April 13, 2023

**ADDENDUM NUMBER TWO (002)**

**City of Burnet / Hill Country Children's Advocacy Center  
Hill Country Children's Advocacy Center  
CDBG-CV Contract No. 70800001002**

| Folding Partition Stack/Pocket Width & Depth                              |                 |                 |                       |                         |

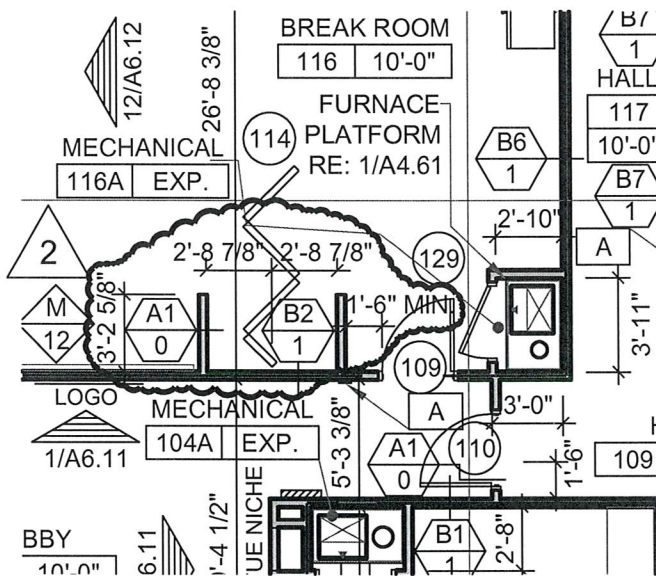
- a. Detail 1 – Refer to the attached sketch – AS1 for modification of the operable door partition in Rooms 115 & 116.
